ADDENDUM NO. 1

State of Maine Ray Building Renovation
28 Tyson Drive
Augusta, ME

April 13, 2022

From: Wood
Environment & Infrastructure Solutions
511 Congress Street
Portland, Maine 04101

A4 RECEPTION DESK
 1 1/2" = 1'-0"

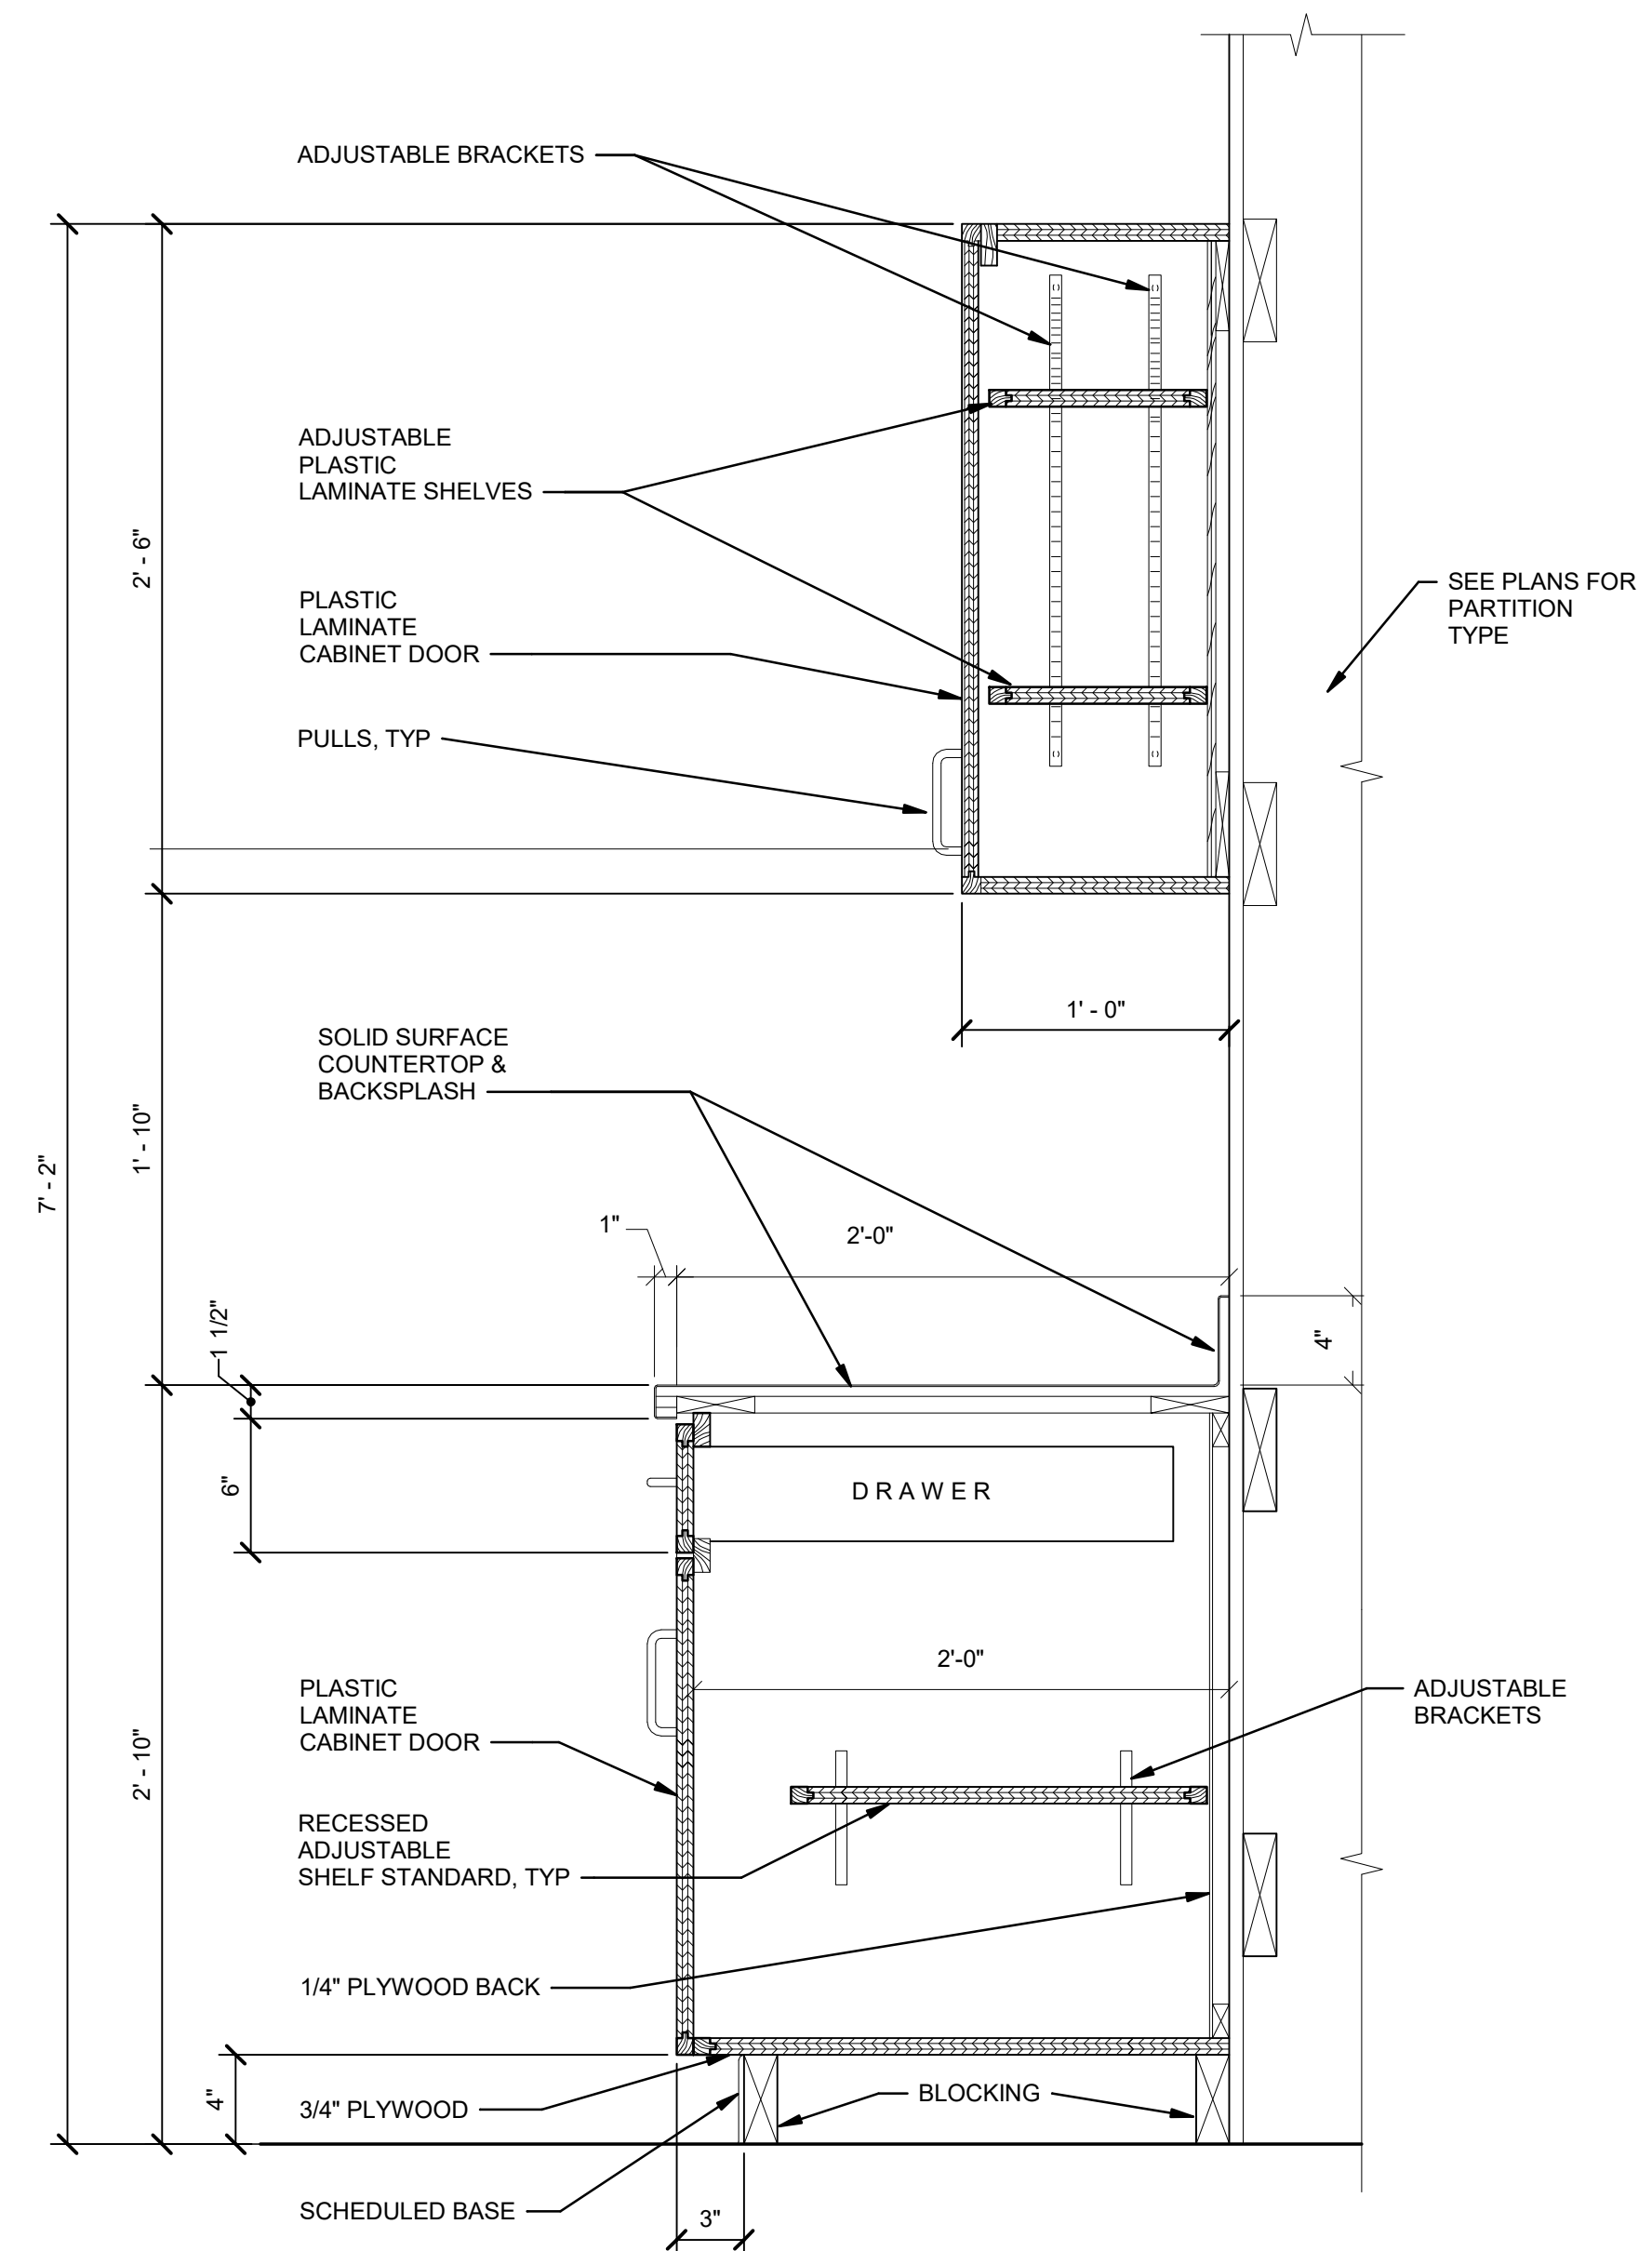
1. REPLACE drawing AE521 with the attached revision dated 04-13-2022. Soffit was removed from around the coiling door hood per RFI#
